CITY OF ST. PETERSBURG, FLORIDA
PLANNING AND DEVELOPMENT SERVICES DEPARTMENT
URBAN PLANNING AND HISTORIC PRESERVATION DIVISION

STAFF REPORT

Community Planning and Preservation Commission Certificate of Appropriateness Request

Review of a Certificate of Appropriateness for replacement of a front door at 2726 Burlington Avenue North, a property proposed for inclusion as a contributing property to a local historic district currently pending public hearing

Figure 3: Typical doors found at local residences displaying the Craftsman style, as shown in St. Petersburg's Design Guidelines for Historic Properties, page 49

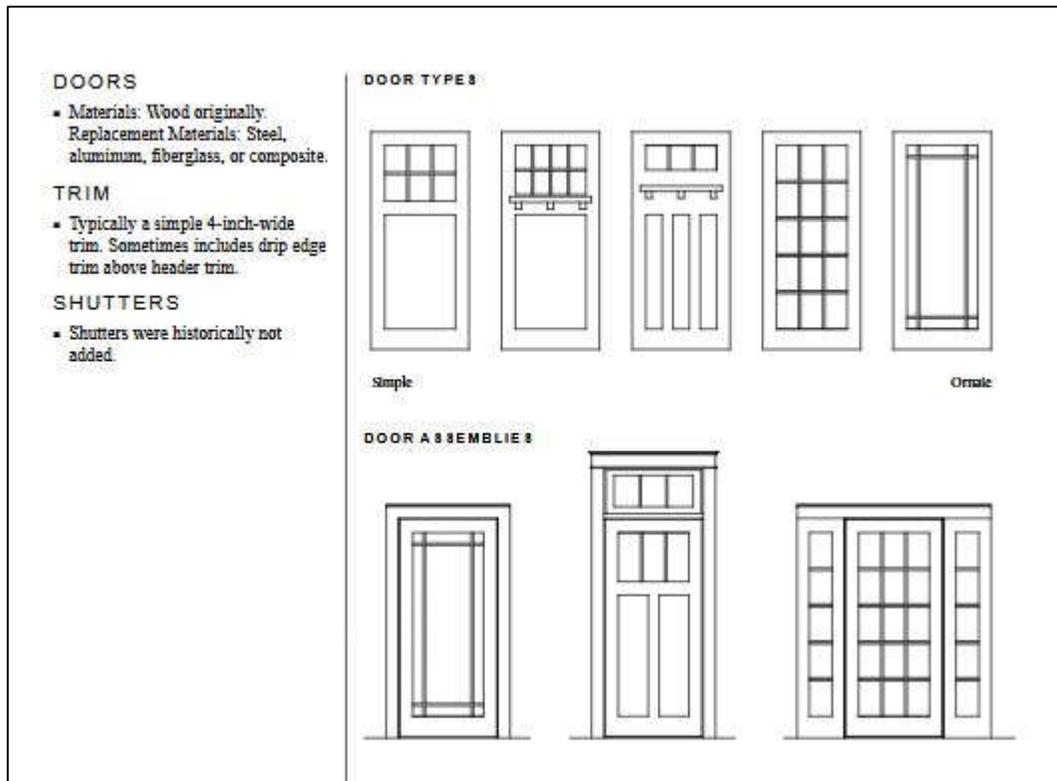
The proposed partially-glazed door with sidelights combines elements commonly found historically in similar resources. Further, both the design of the paneled door with glazing at the upper portion, and the door assembly

composed of a single-action door and sidelights, are recommended features of the Craftsman style by St. Petersburg's Design Guidelines for Historic Properties.

Figure 2. Current entry doors. Photos taken 27 August 2020.

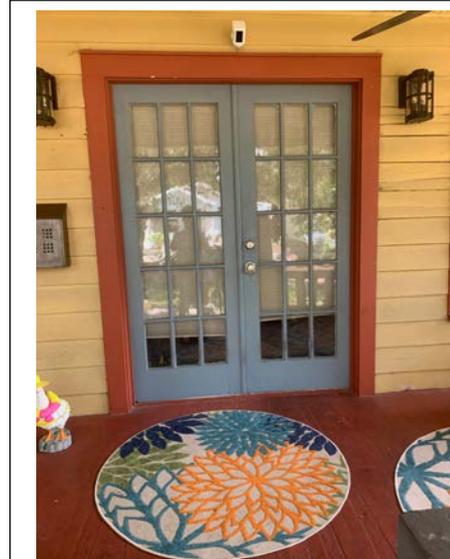
The current doors (**Figure 2**) are rather unusual on 1920s-era Craftsman bungalows, being double-entry, French doors with glass panels. We contend they are not original, which should allow us to choose a design more in line with typical Craftsman architecture. Supporting evidence for this is:

Figure 4. Remnants of former entry in porch enclosure. Photos taken 27 August 2020.

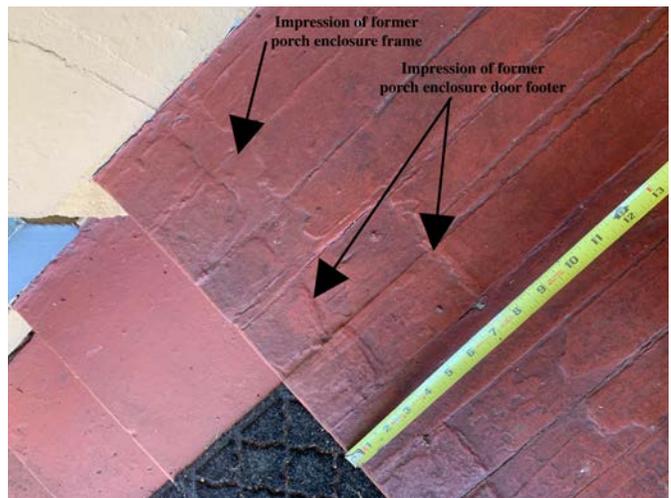
1. ***Our porch was previously enclosed.*** There is residual evidence of the enclosure remaining in the paint and wood of the siding, porch, and columns of the porch (**Figure 3**). These marks include an obvious header and footer for an entryway between the half-columns in the middle of the porch (**Figure 4**), indicating another external door. A picture from a 1994 survey (**Appendix A**) shows the porch enclosure either being removed or converted to a screened porch. Unfortunately, the picture is a black and white scan and of poor quality and the doors are not shown. We suspect this shows the porch being converted to a screened in porch, since neighbors informed us it was still

Figure 5. (left) Door jamb for left door showing slot for a mortice-type lock. (right) corresponding location on right door showing no hole for the mortice-lock assembly. Photos taken 27 August 2020.

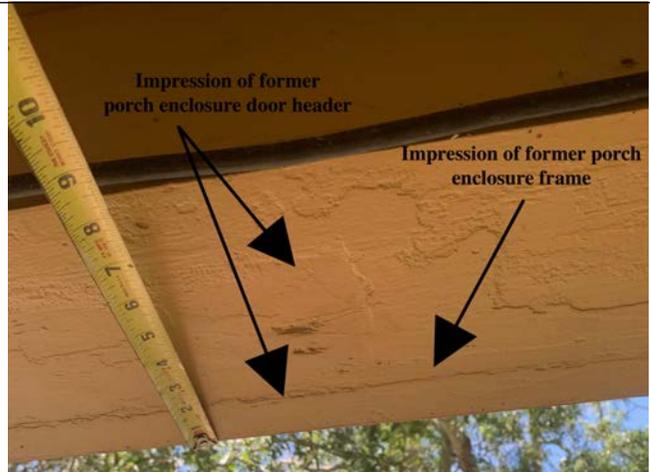
4. ***There is a depression for a mortice lock bolt on one door, but no corresponding place for the mortice lock assembly on the other door (Figure 5).*** This suggests to us that these doors were not originally a pair. Perhaps one was damaged and replaced with a similar salvaged door. Equally plausible is the two doors were salvaged to create the door at some point in the past, most likely when the porch was enclosed and a new external doorway was created.
